Invitation for Bid No. 2026-037

Walden Pond Dredge Project

ADDENDUM No. 2

ISSUE DATE: November 19, 2025

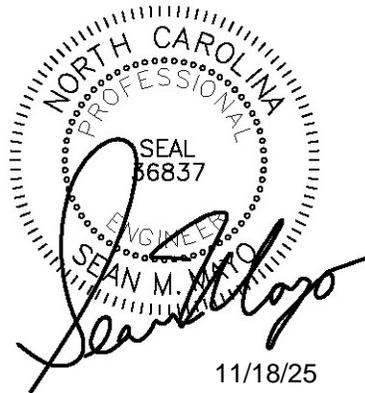
Question: Does the material that's being hauled offsite have to go to a permitted site.

Response: Yes. All spoils shall comply with applicable State regulations. As per Note 12 of Project Erosion Control Notes: *"Any Off-Site Borrow And Waste Required For This Project Must Come From A Site With An Approved Erosion Control Plan, A Site Regulated Under The Mining Act Of 1971, Or A Landfill Regulated By The Division Of Solid Waste Management. Trash/Debris From Demolition*

Activities Or Generated By Any Activities On Site Must Be Disposed Of At A Facility Regulated By The Division Of Solid Waste Management Or Per Division Of Solid Waste Management Or Division Of Water Resources Rules And Regulations.”
